| Charlotte Historic District Commission |
| Staff Review |
| HDC 2016-191 |

| PROPERTY ADDRESS: | 1948 Park Road |

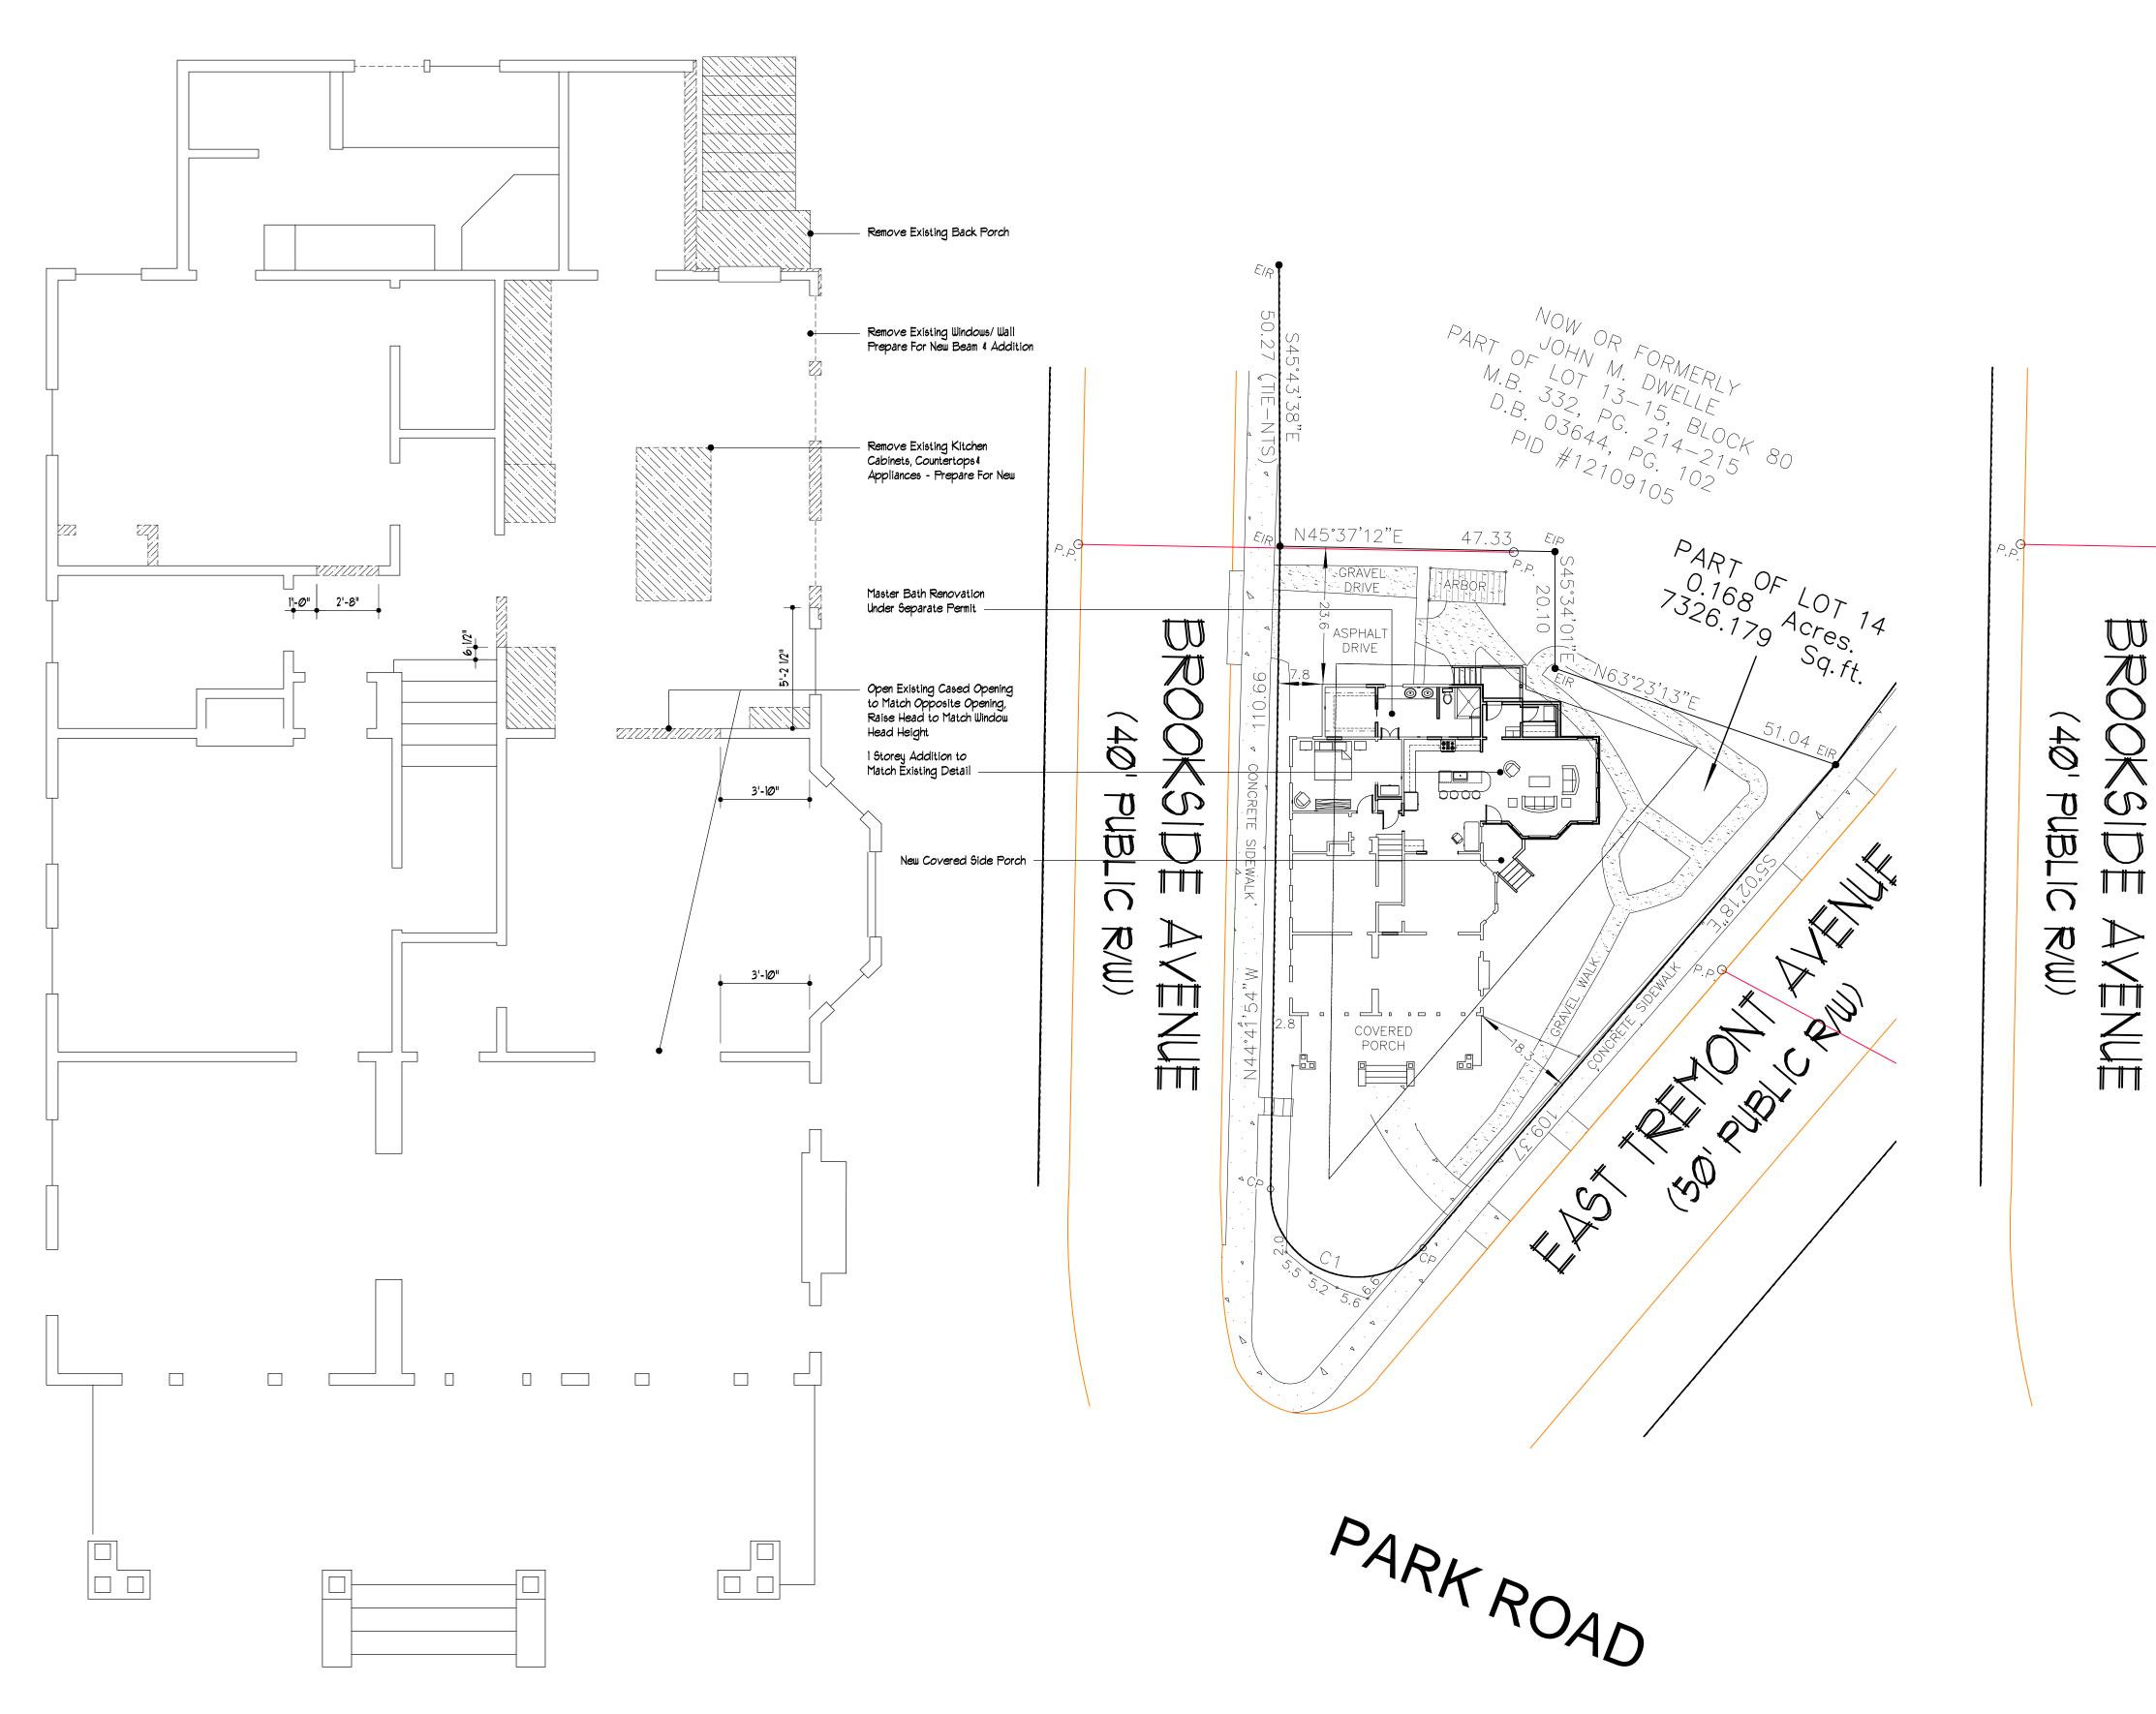
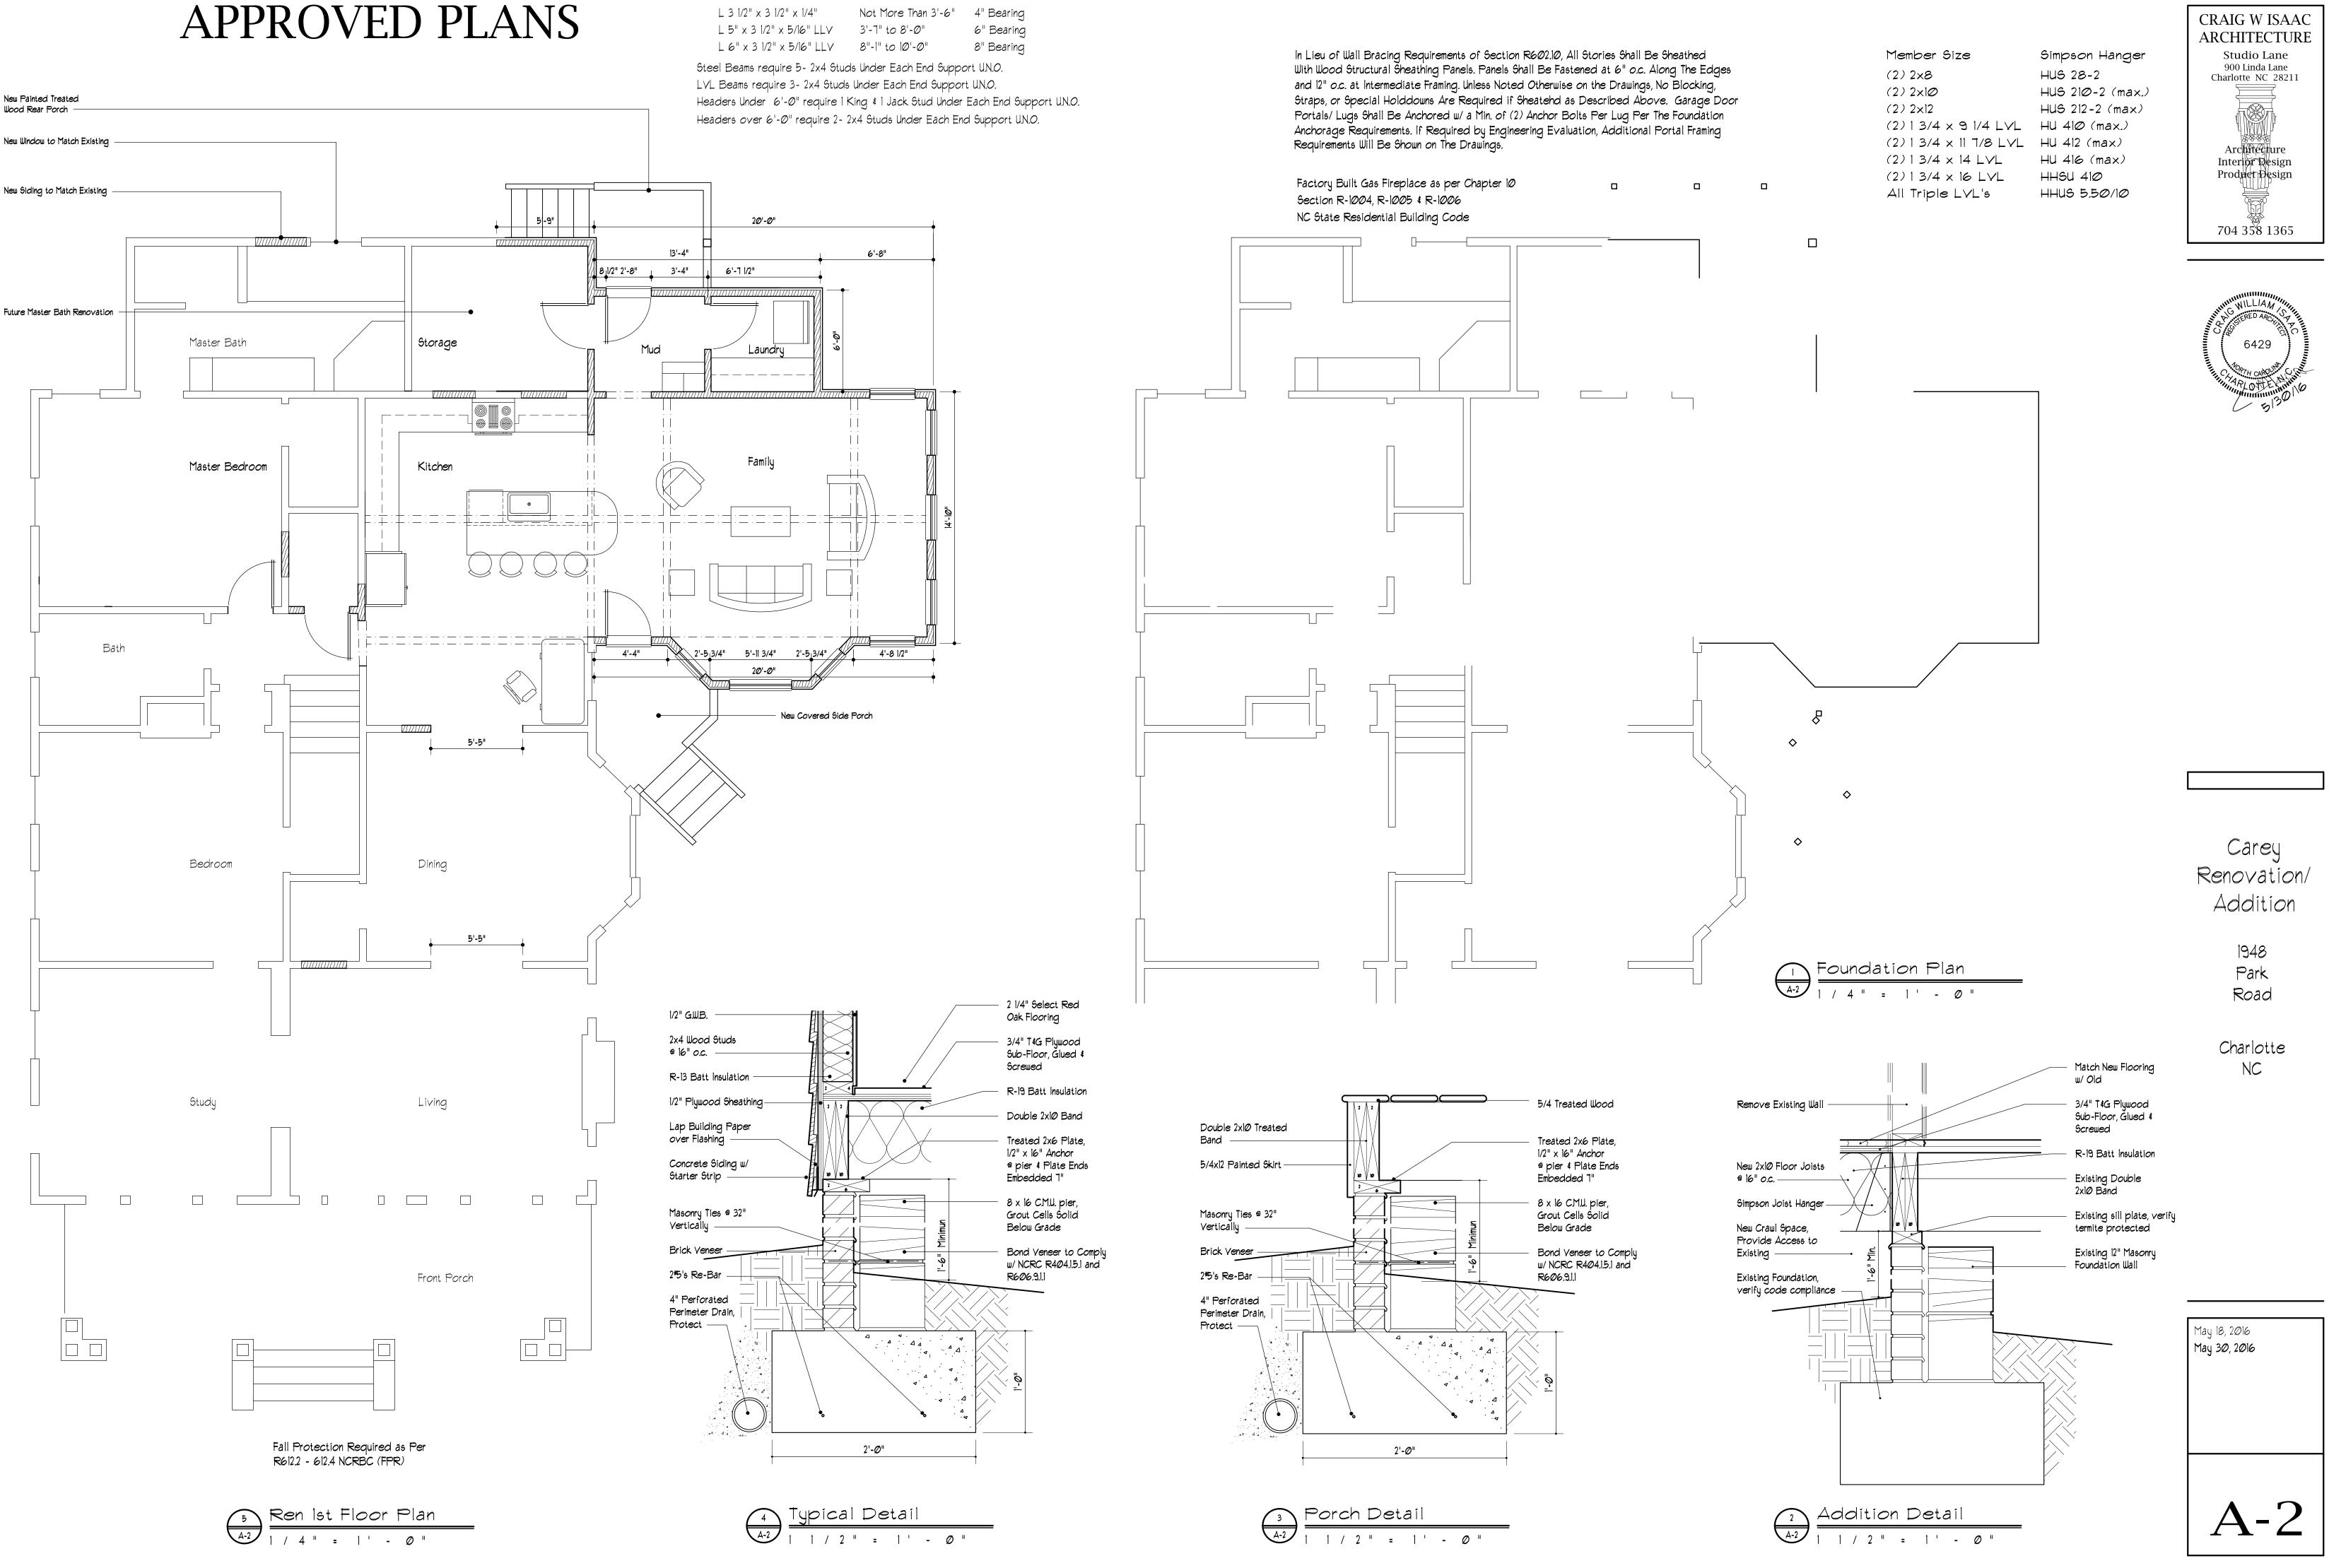
A small one story addition was approved by the HDC June 8, 2016. Details of the motion - *Disconnect the roofline at the side back door, and the stairway, it is going to be a window instead of a door and screen.*

The applicant is applying for a revision to the side addition which includes a simplified roof connection and a stair and door from the interior living space. New materials, windows and trim will match existing. The rear porch addition was approved.

<u>Staff Analysis</u> The Commission will determine if the proposal meets the guidelines for additions.
